Project name: Webster ISB Phase 1

Drawing No.	Revision No.	Placing drawing description
R01-01	1	Level 0 Found Elevation Plan & Sections
R01-02	0	Level 0 East/West Grade Beam & Wall Elevations
R01-03	0	Level 0 East/West Grade Beam & Wall Elevations

RE: steel reinforcement shop drawings level 00
foundation grade

Subject: 03 3000 Cast-In-Place Concrete –
Steel Reinforcing Shop Drawings –
Level 00 Foundation Grade Beams,
Walls, and Pilasters

2 SECTION
SCALE: 1/2"=1'-0"

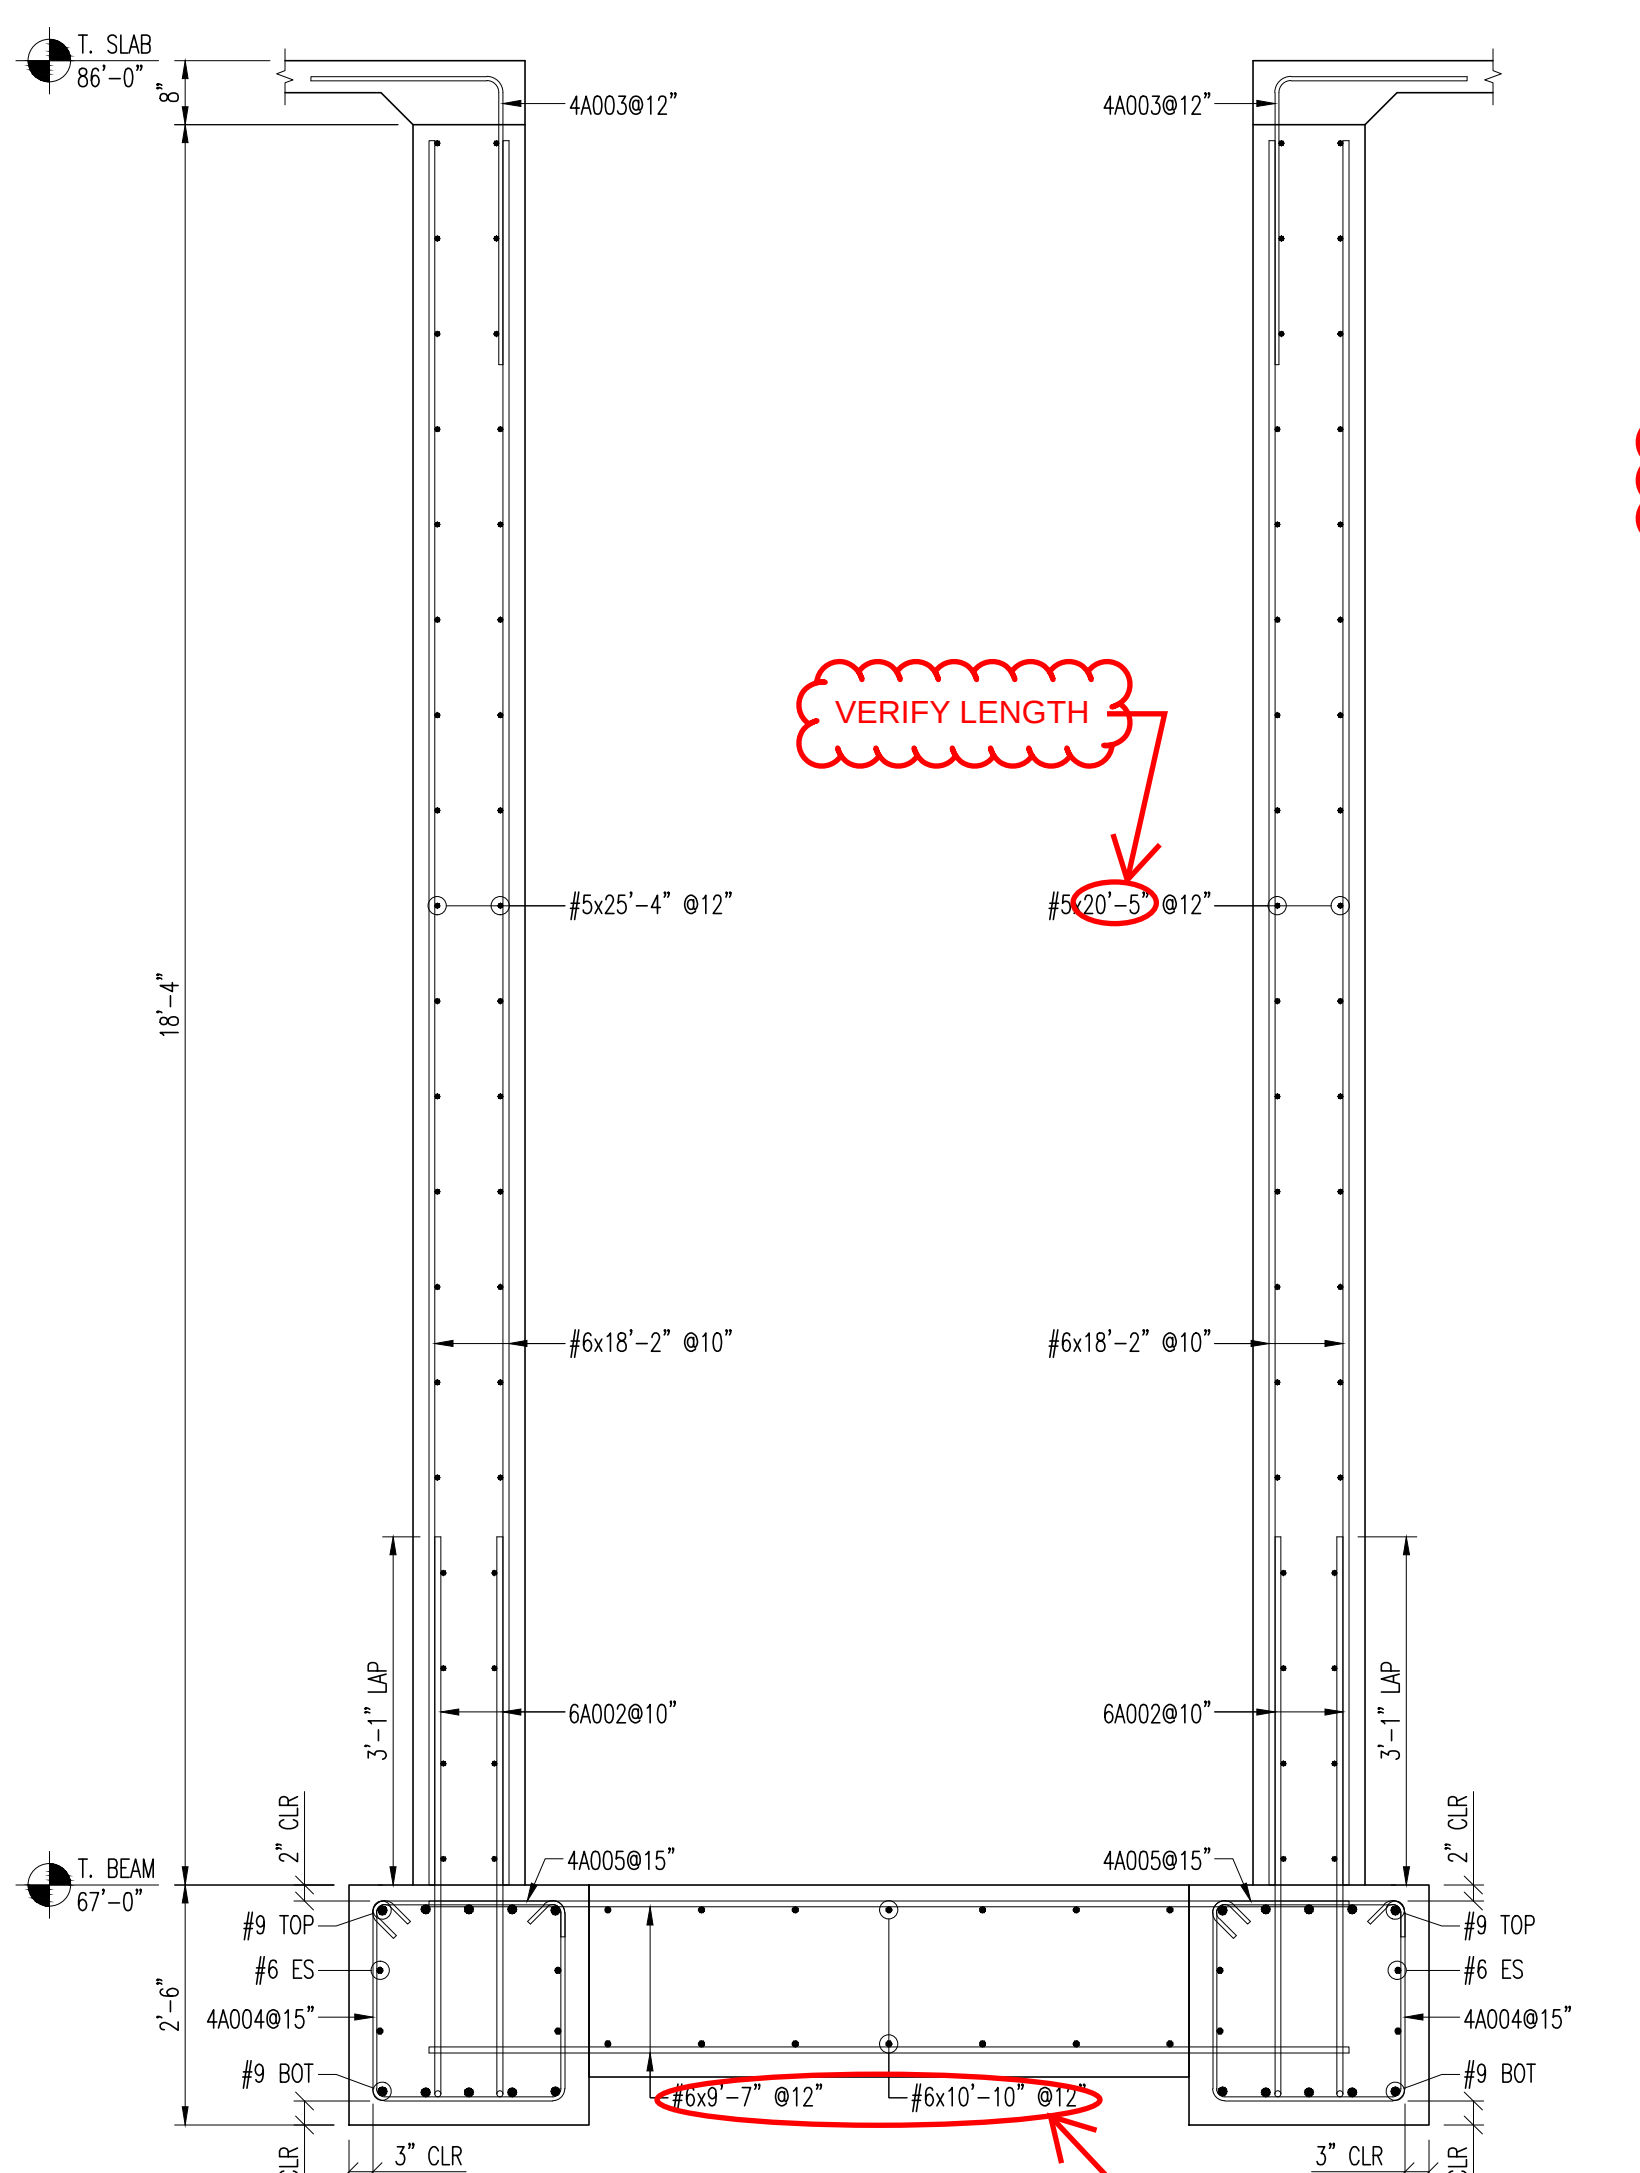
10'-5"
VERIFY

VERIFY LENGTH

VERIFY LENGTHS

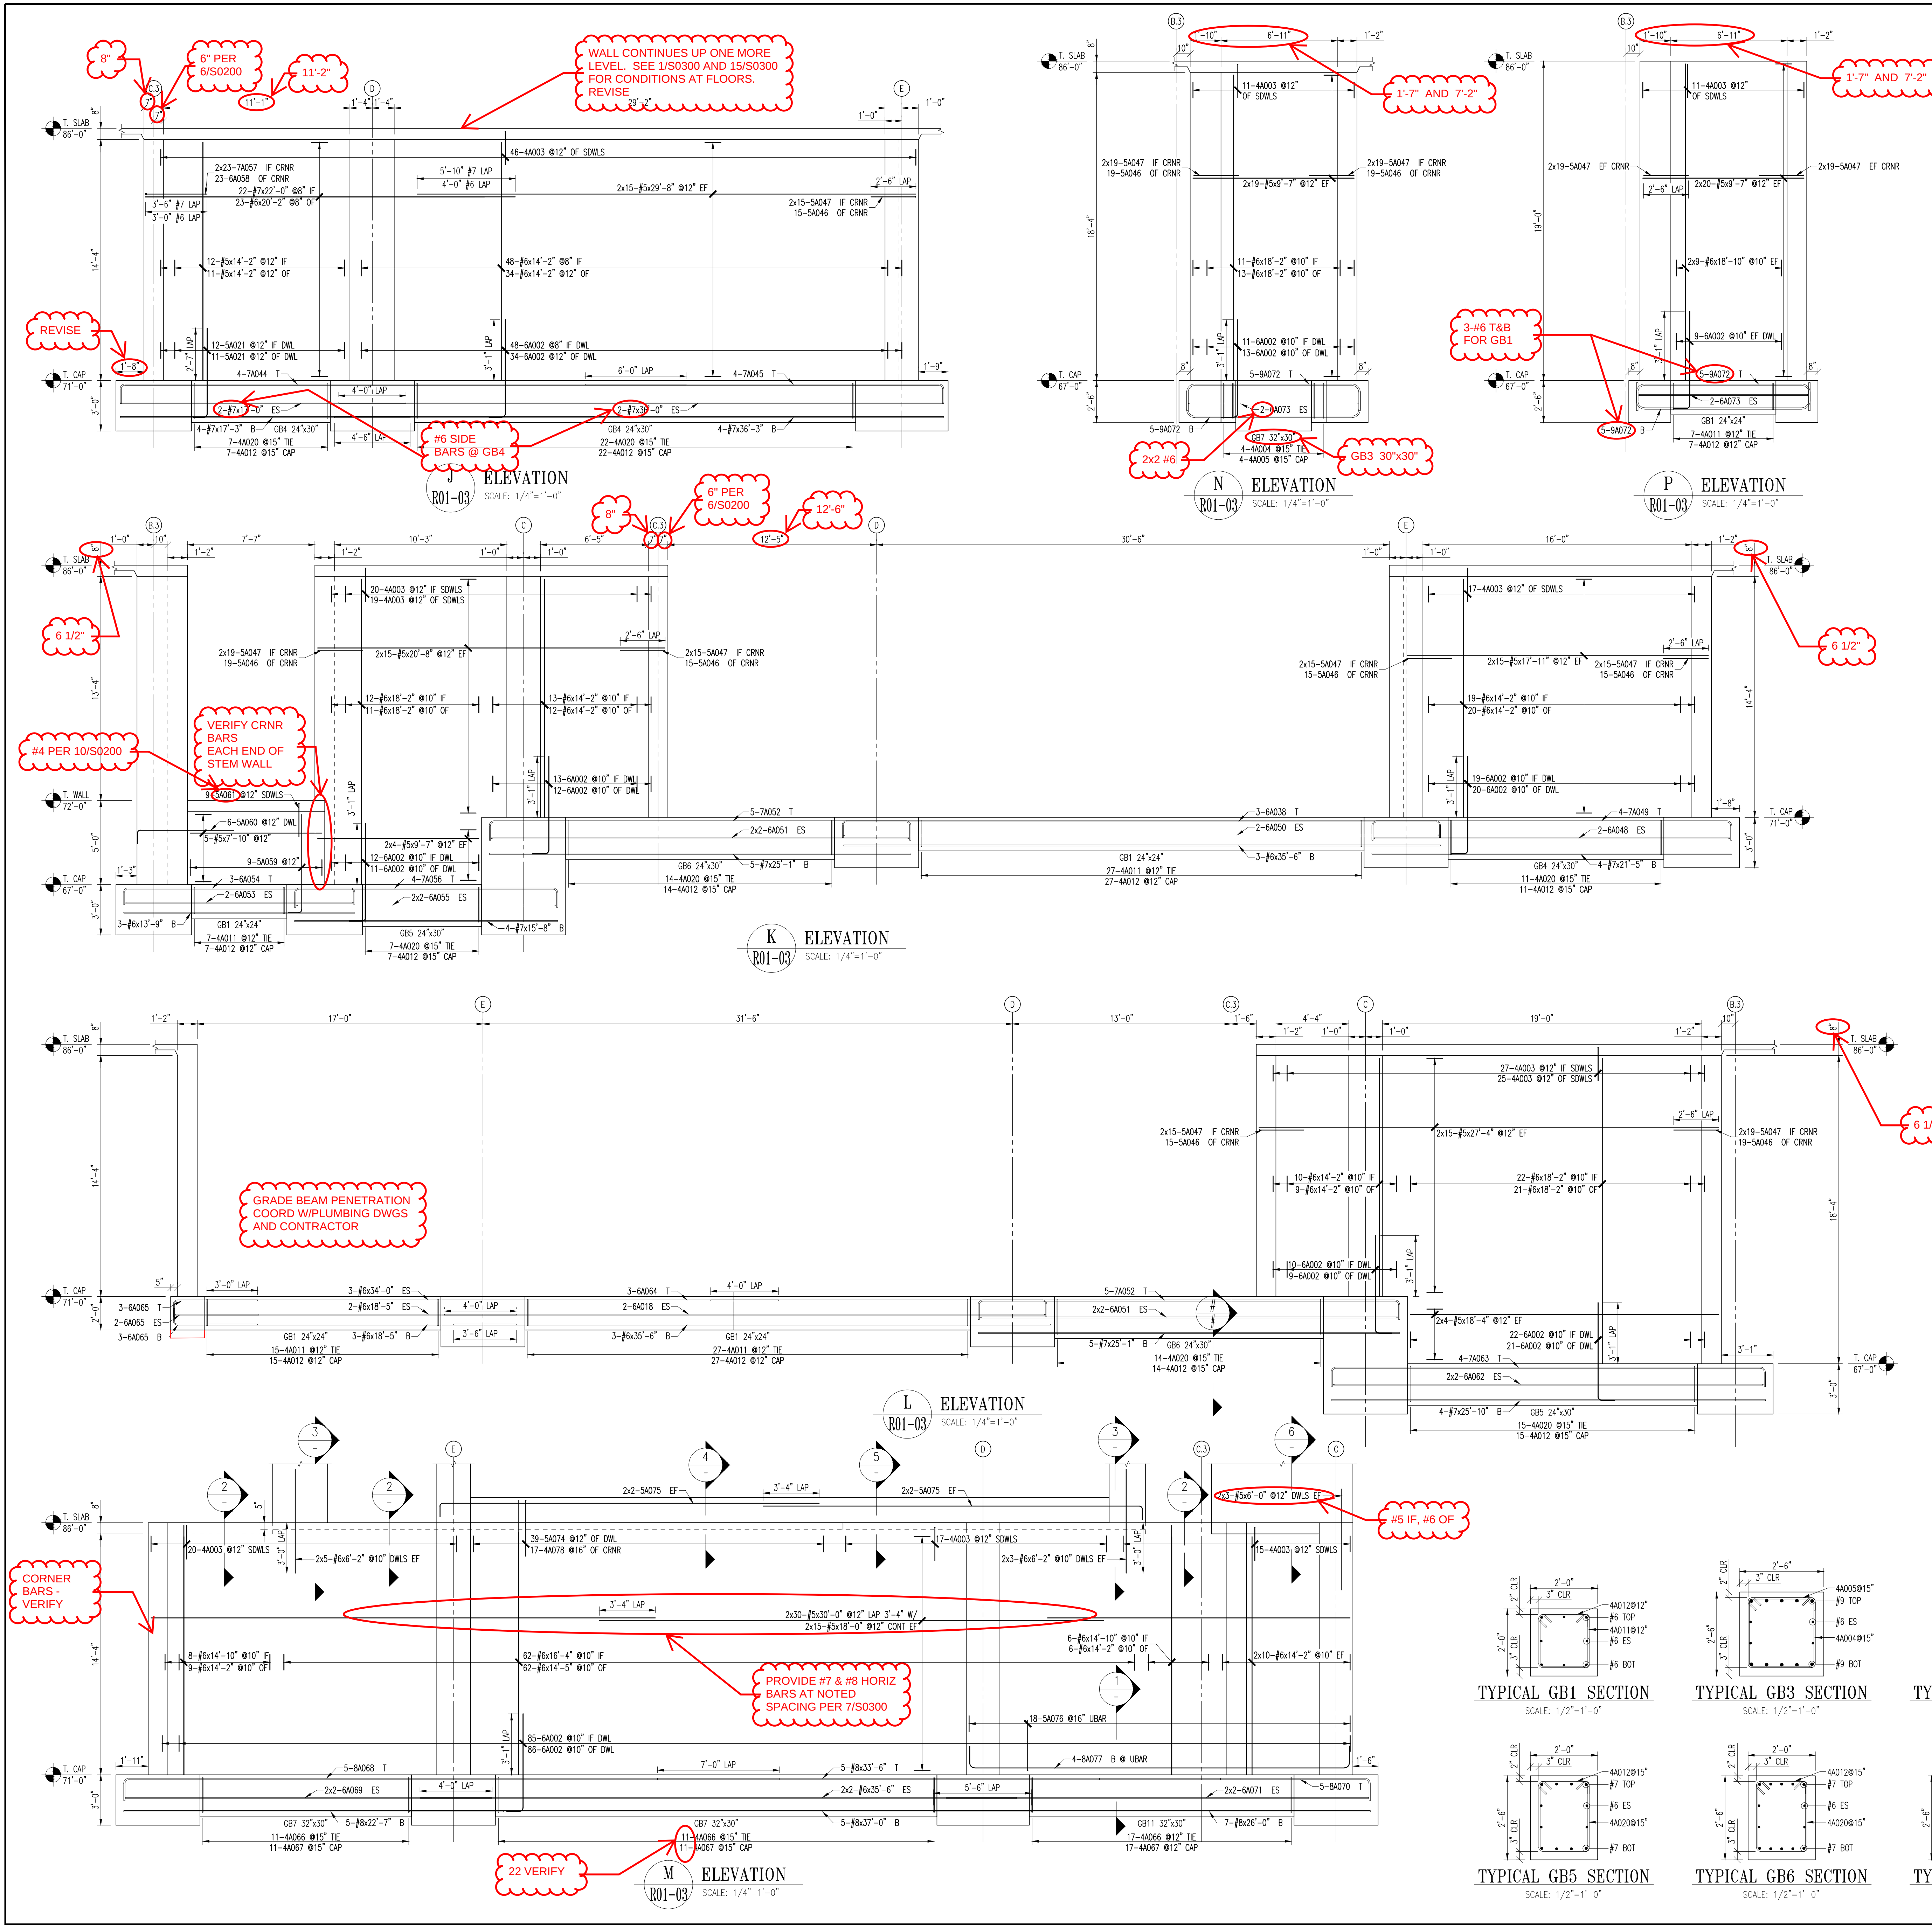
CONTRACTOR OPTION:
KEEP TOP OF WALLS THIS
LEVEL AT -6 1/2" IN LIEU OF
STEPPING FROM -8".

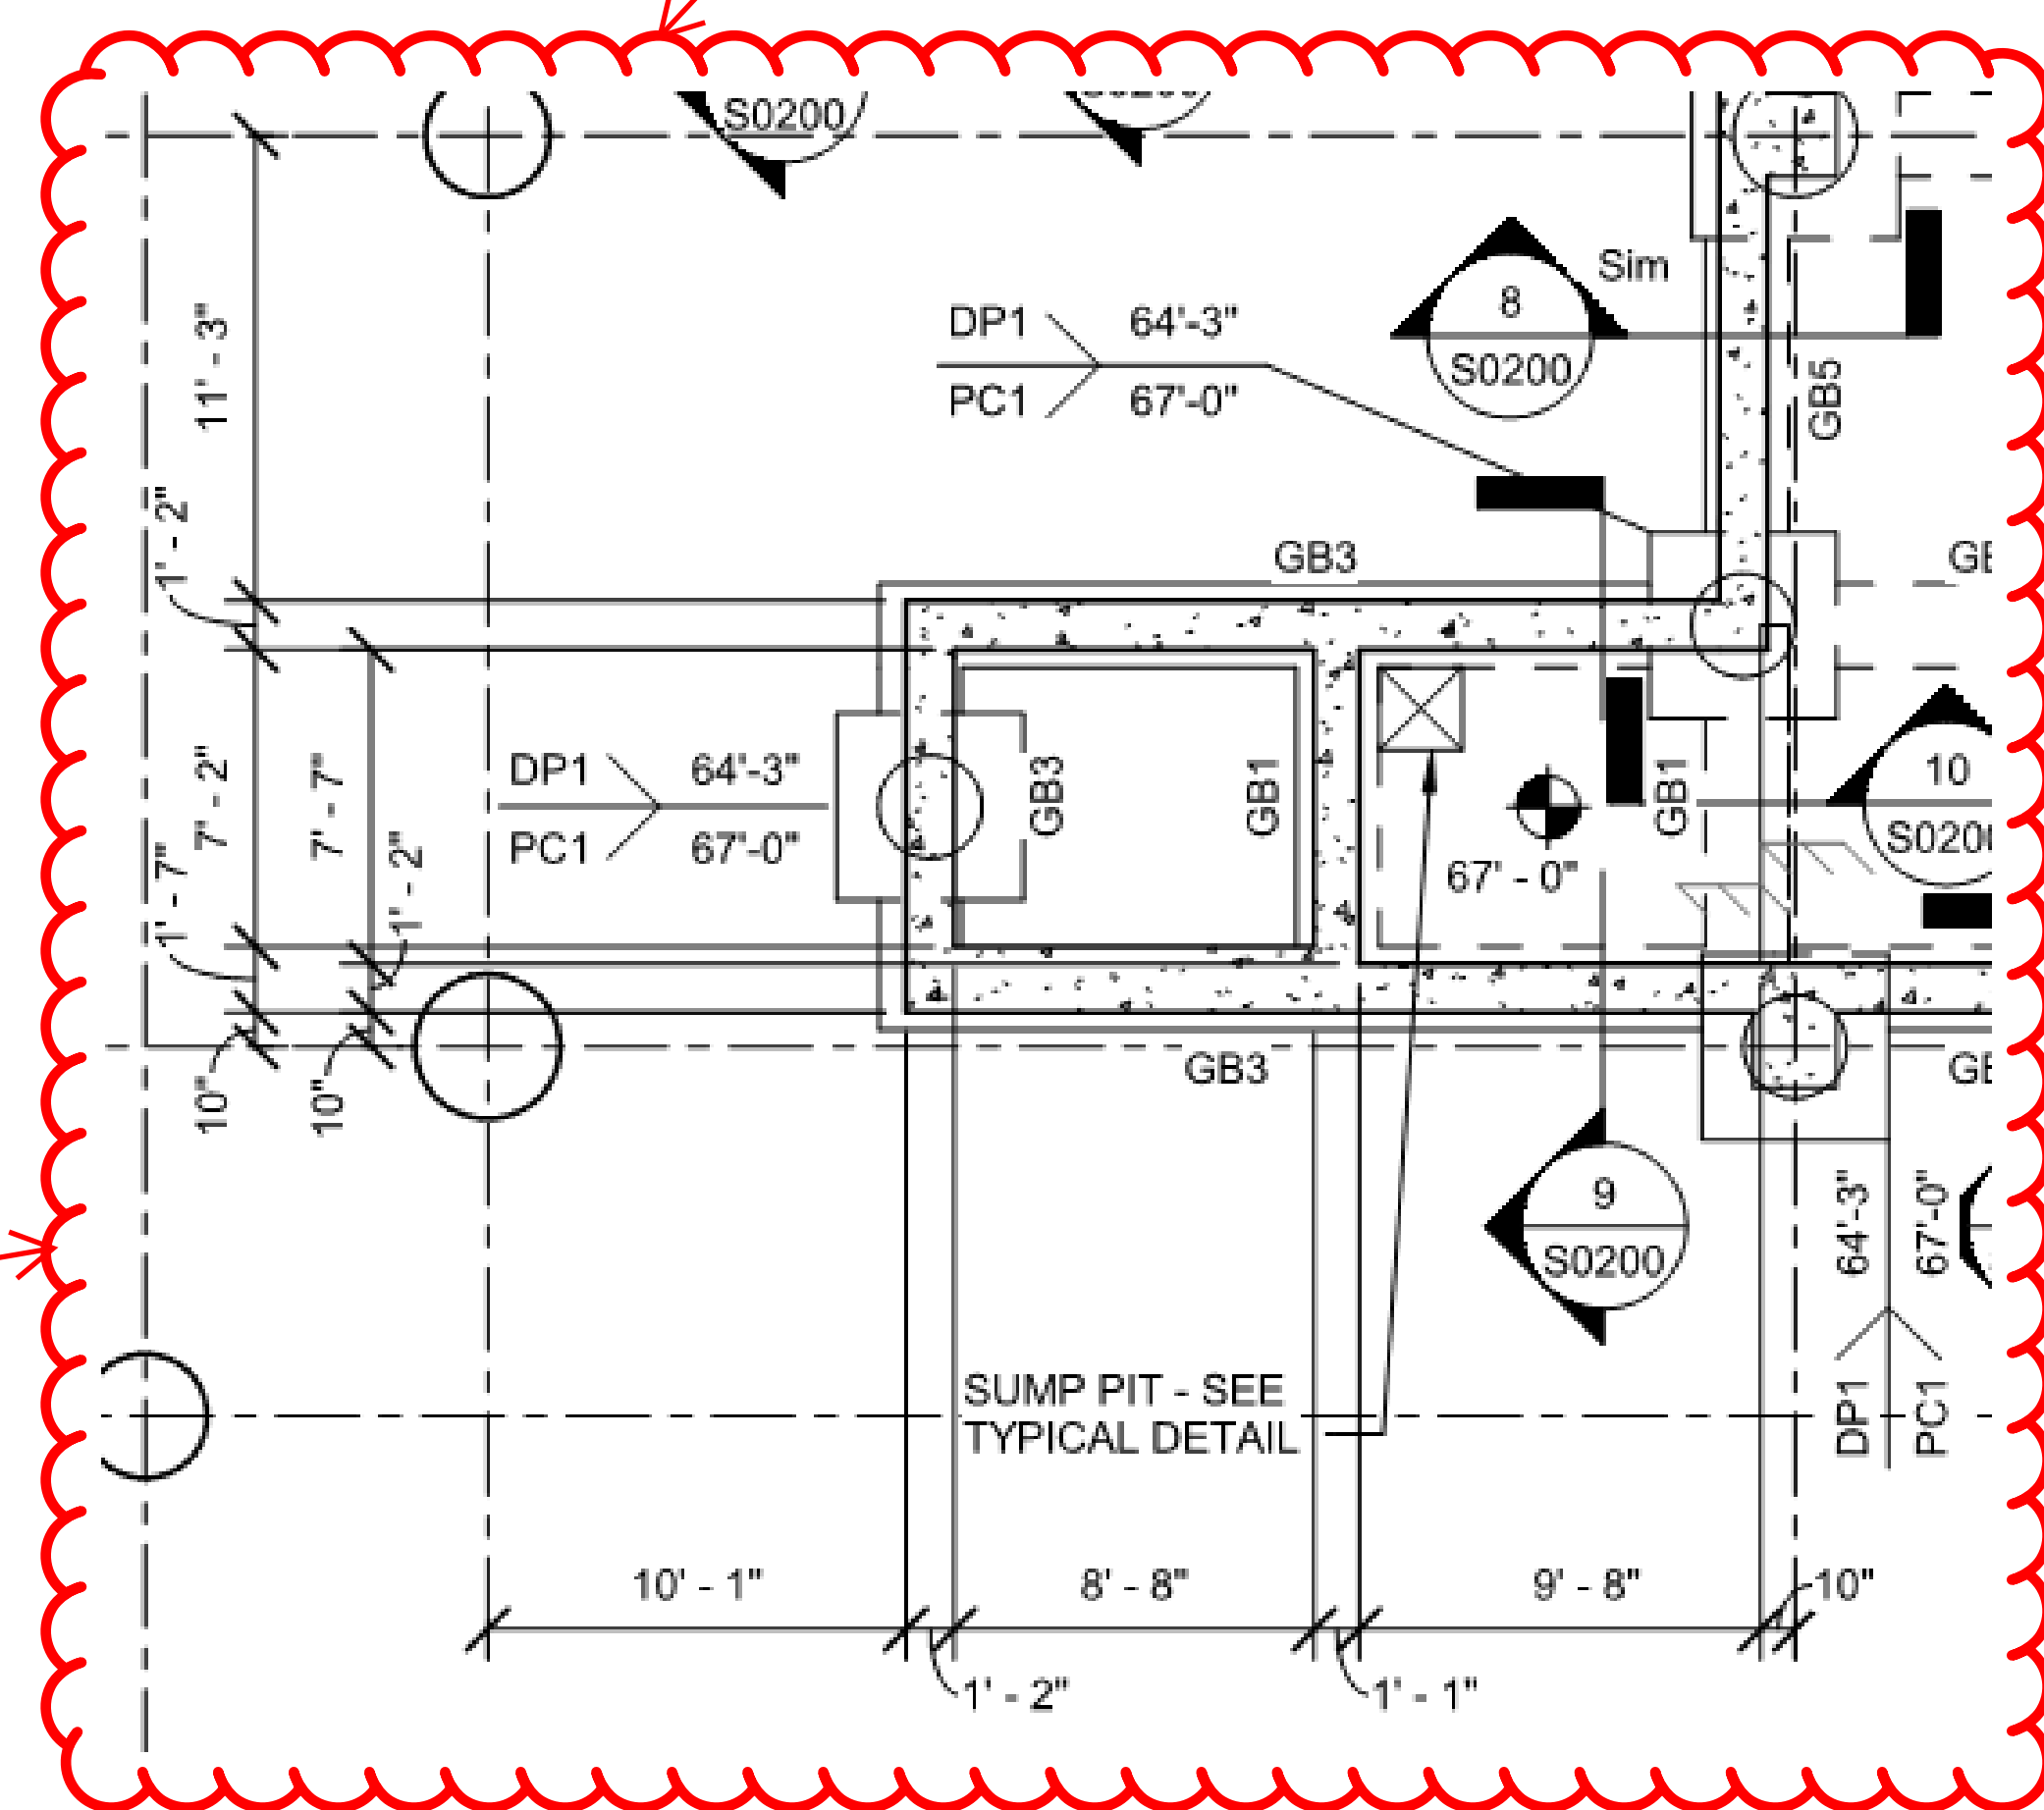
NOTE ELEVATOR PIT
AND WALL DIMENSIONS.
GC TO COORD FINAL
INFORMATION
W/ELEVATOR MANUF
